February 9, 2018

**Re:** Responses to Comments of Cell 17 Draft Substantial Modification Application  
Pasco County – Solid Waste  
Facility Name: Enterprise Road Class III Recycling and Disposal  
Facility Site ID: 87895  
DEP Application Nos.: 177982-023-SC/T3 and 177982-024-SO/T3

Thank you for your review of the above-referenced permit modification draft for the Enterprise Road Class III Recycling and Disposal Facility. The following information is provided in response to the FDEP's draft comments email dated October 17, 2017. Information is provided in the order requested in the referenced correspondence. In each case, the Department's request is stated in italics with the response immediately following in **bold**.

PROJECT NO.:	02000-217-17
SCALE:	AS SHOWN
DATE:	AUGUST 2017
DRAWING:	C3.00

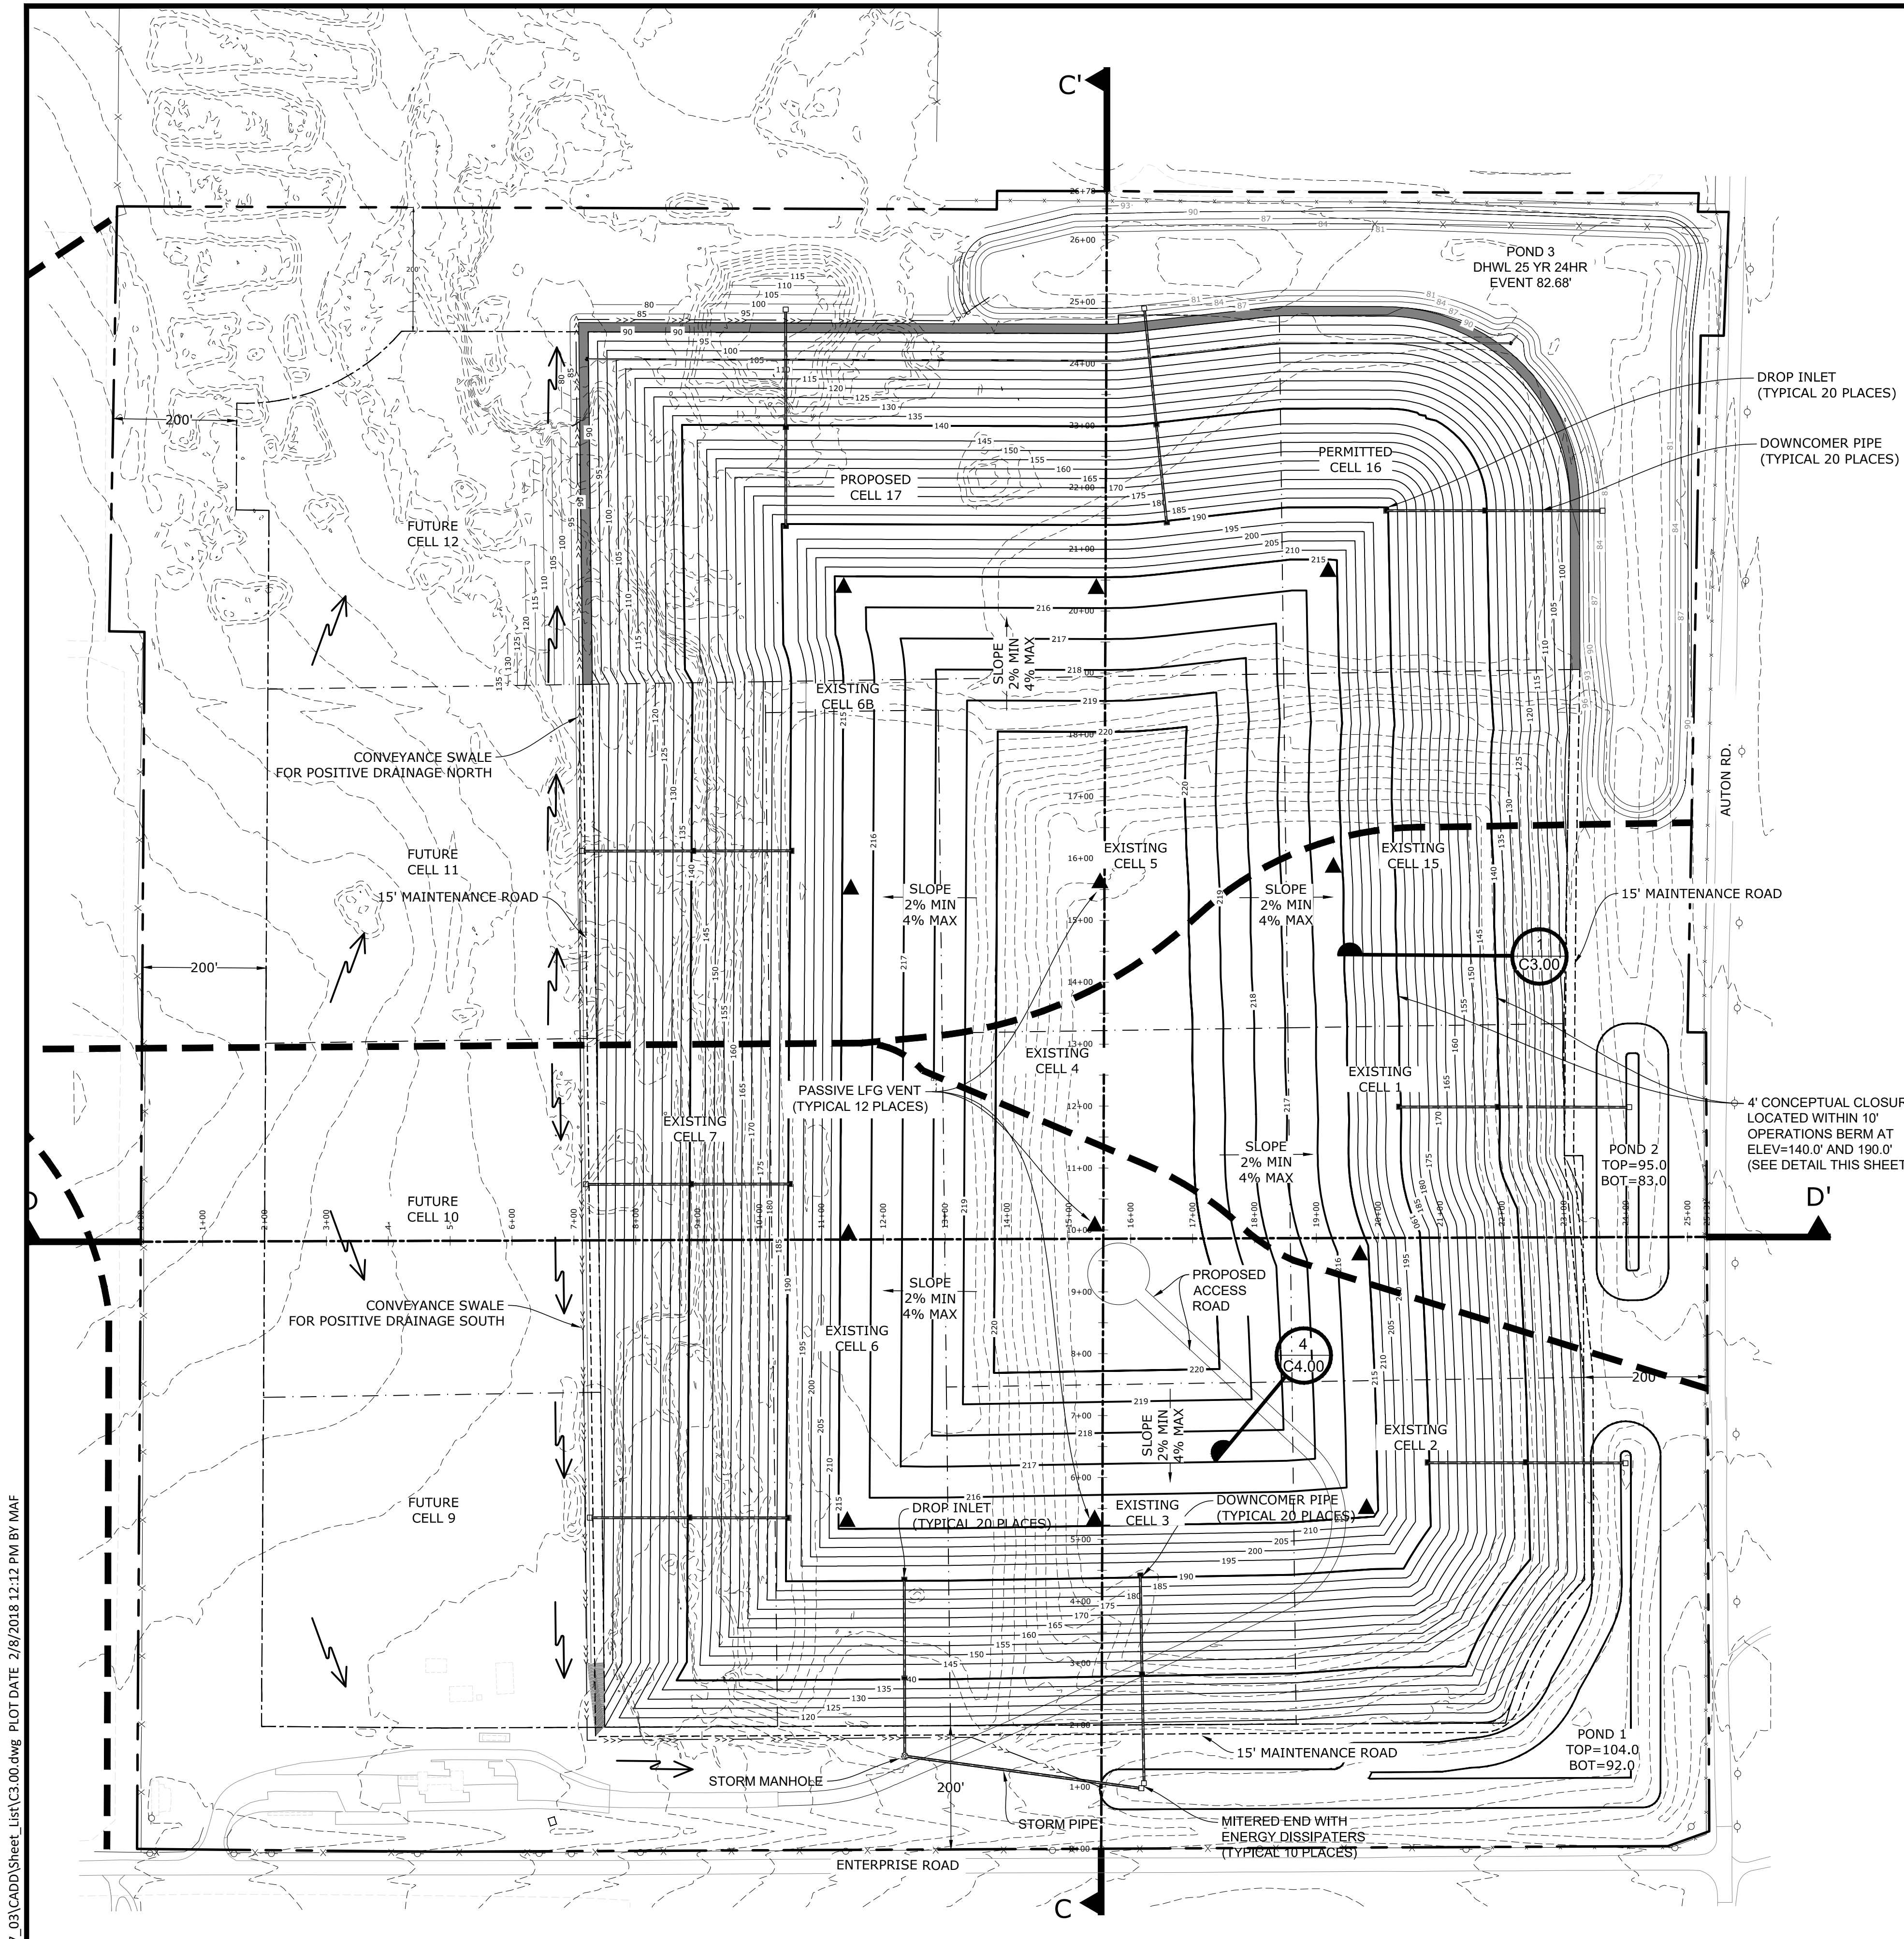
b. *Passive Gas Vents: The passive gas vents are not shown on Sheet C3.00 as indicated. Based on the proposed vertical expansion, Figure 3-16 from 2012 is likely outdated also.*

1) The passive wells are not shown on Sheet C3.00.

1) The landfill monitoring probes are not shown on Sheet C3.00. Please verify the number of probes to be installed in the future.

b. Sheet C3.00 shows 12 passive gas vents and Figure 3-16 has been revised.

**RESPONSE 55:** a1. Sheet C3.00 shows the passive gas wells.

b. Sheet C3.00 has been revised to show the landfill gas monitoring probes. The FACE has been revised to include the number of future probes.

PROJECT NO.:	02000-217-17
SCALE:	AS SHOWN
DATE:	AUGUST 2017
DRAWING:	C3.10

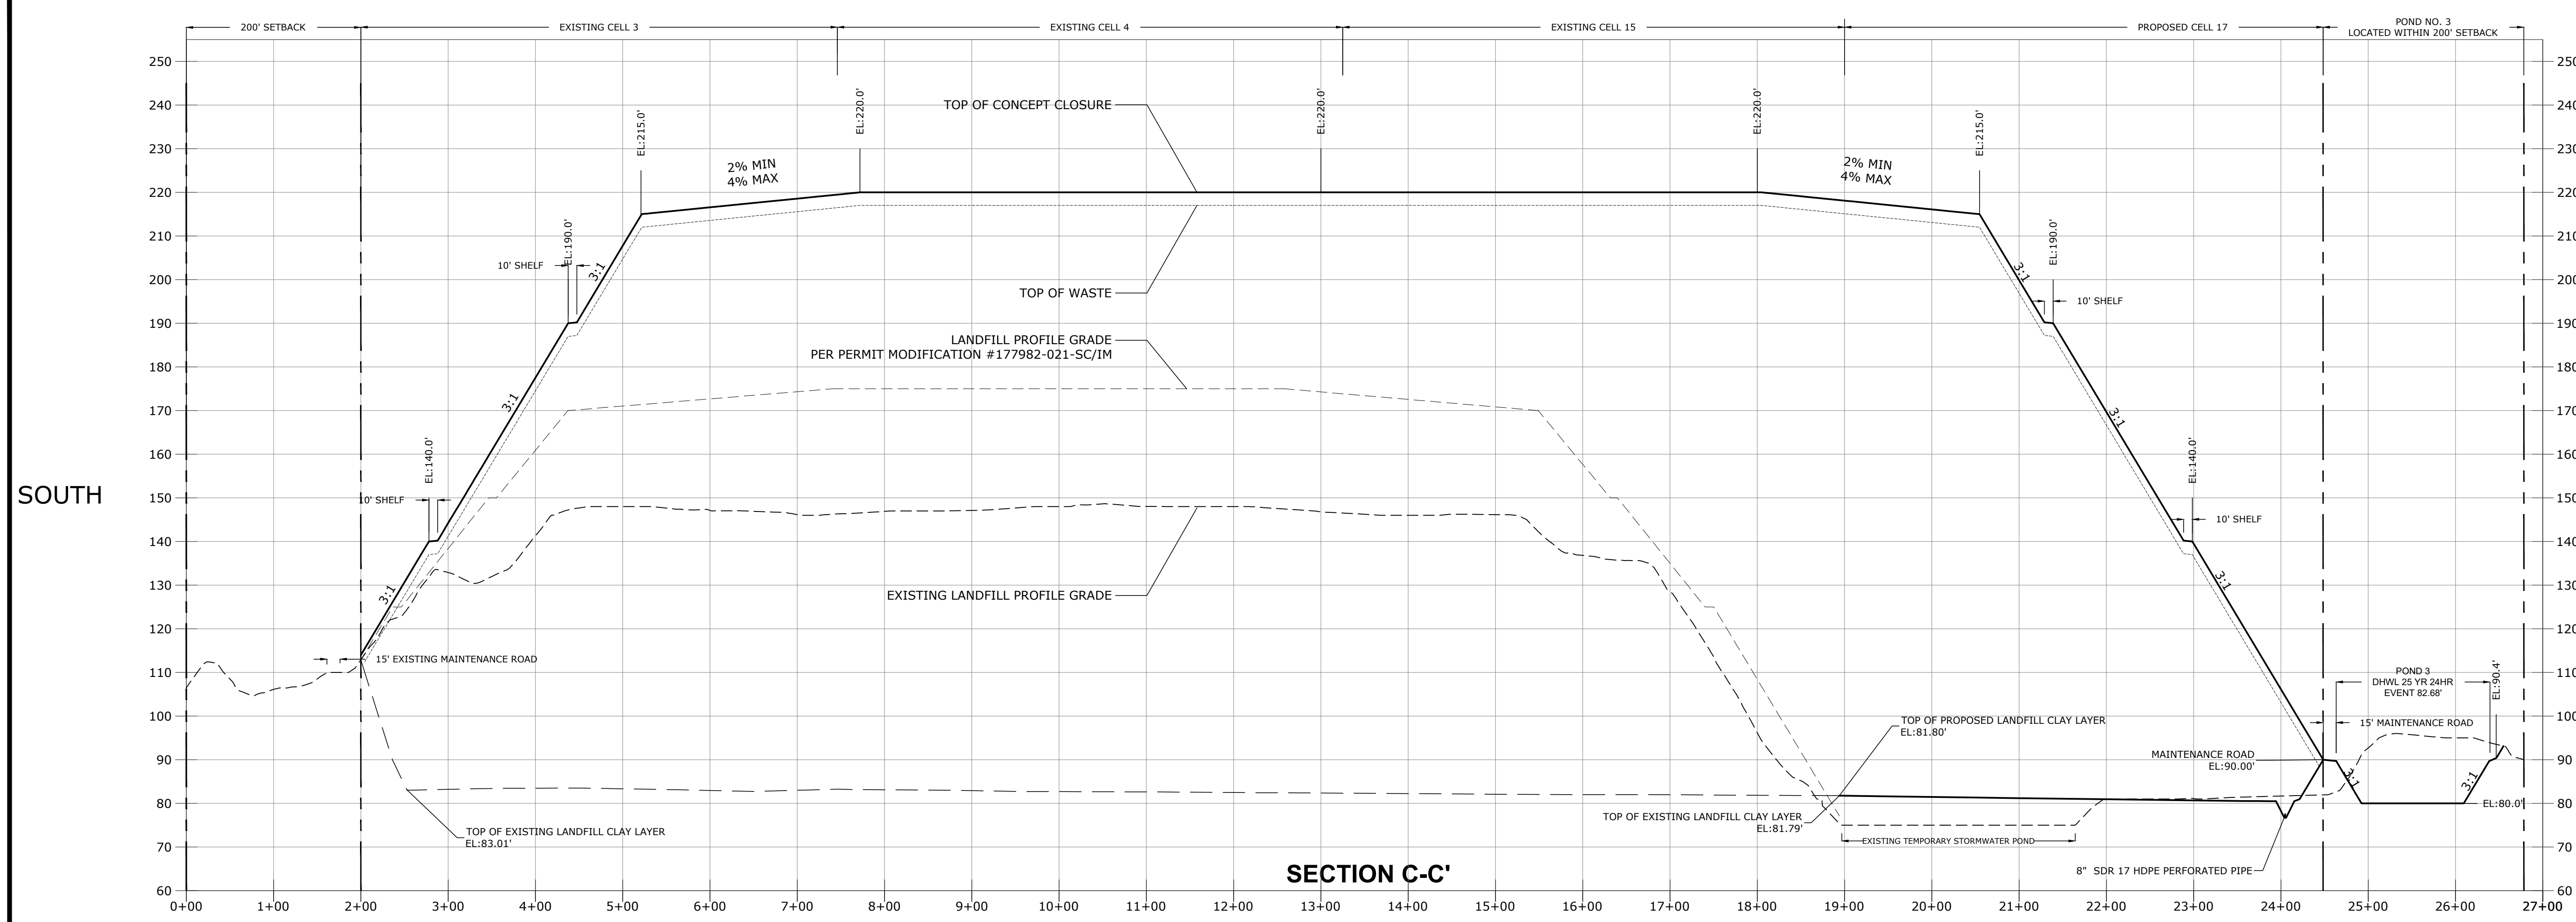
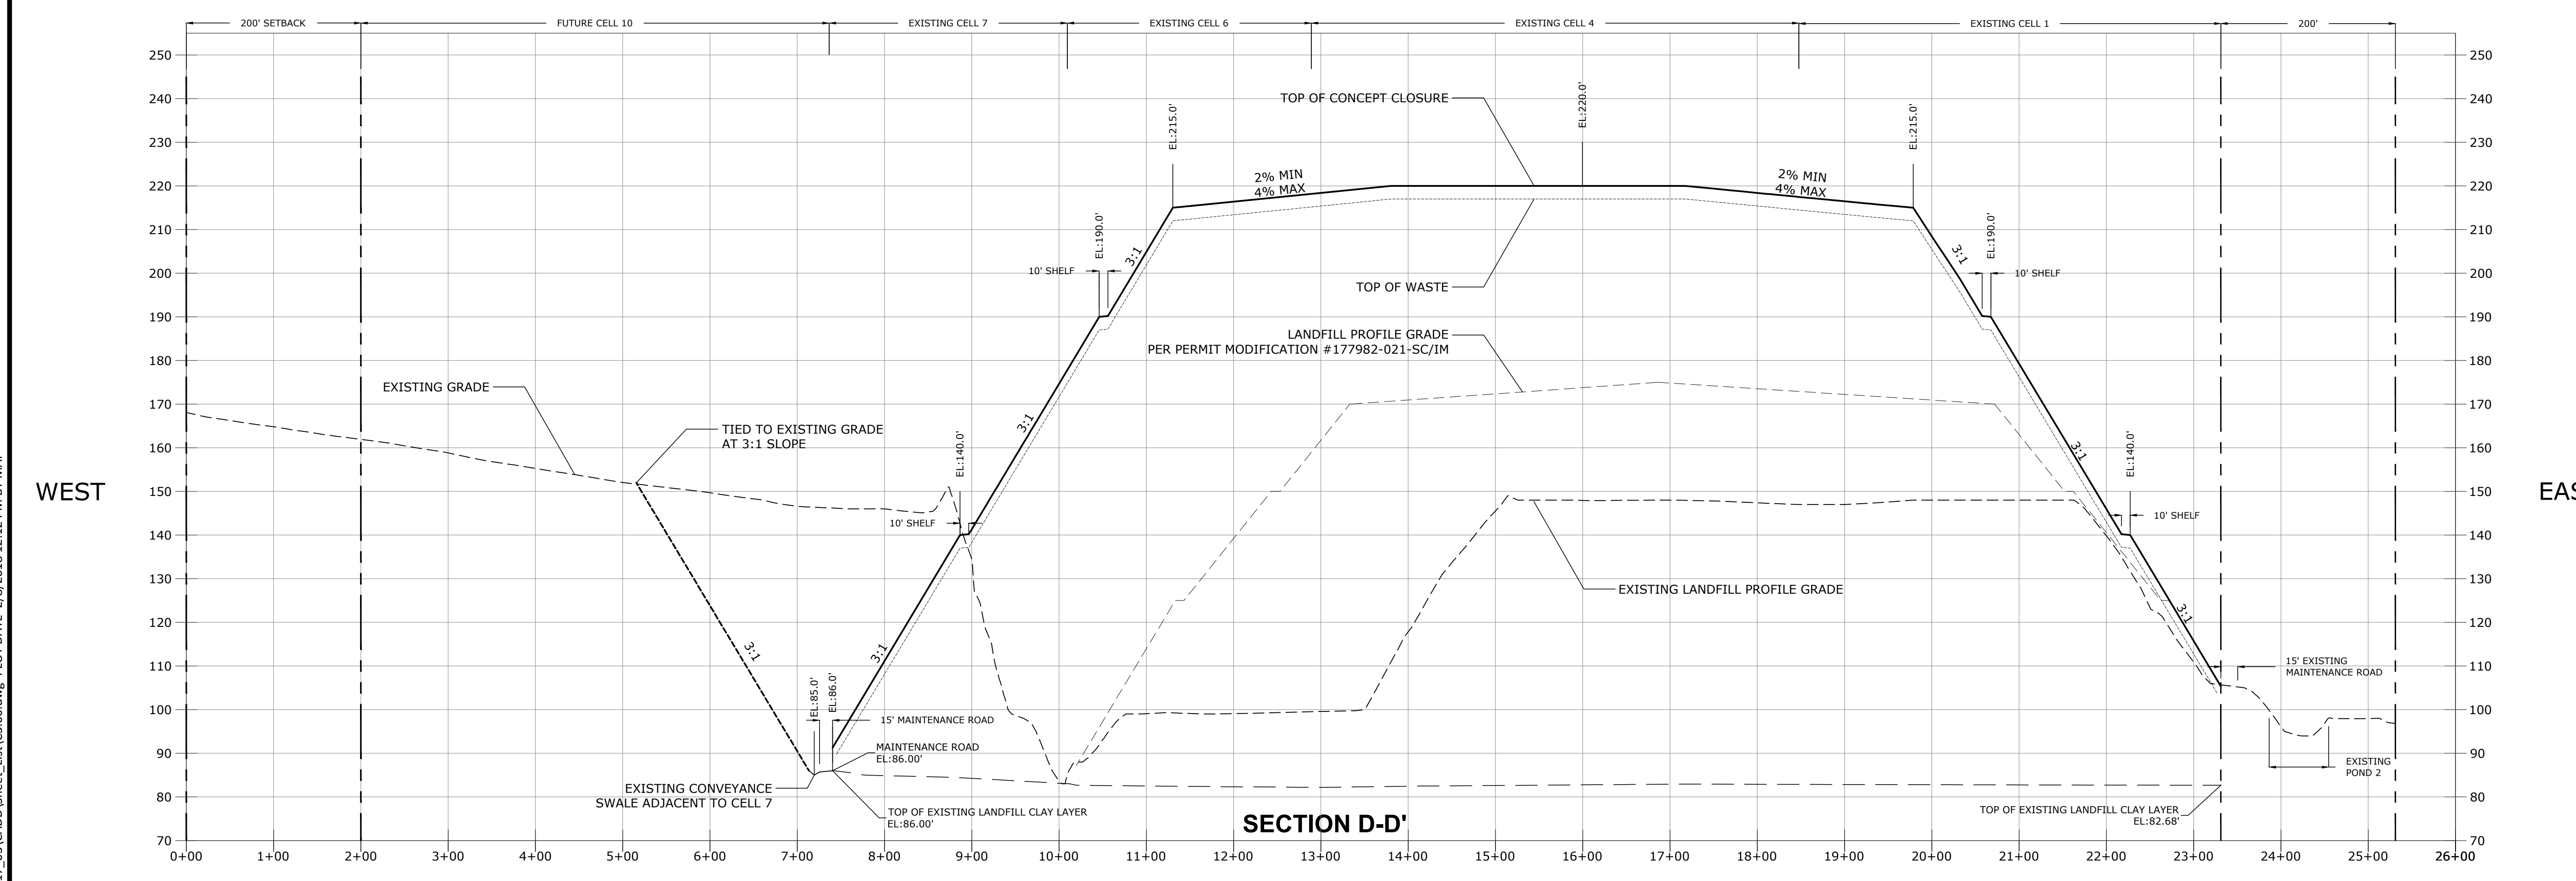
*Comment 46: Drawings C1.01, C1.11, C2.10 and C3.10: The "Permitted Kelner Landfill Profile Grade" was modified by Permit Modification #177982-021-SC/IM. Drawings should be updated accordingly.*

**RESPONSE 46:** Drawings C1.01, C1.11, C2.10 and C3.10 have been revised to include the profile grade in accordance with the referenced permit modification.
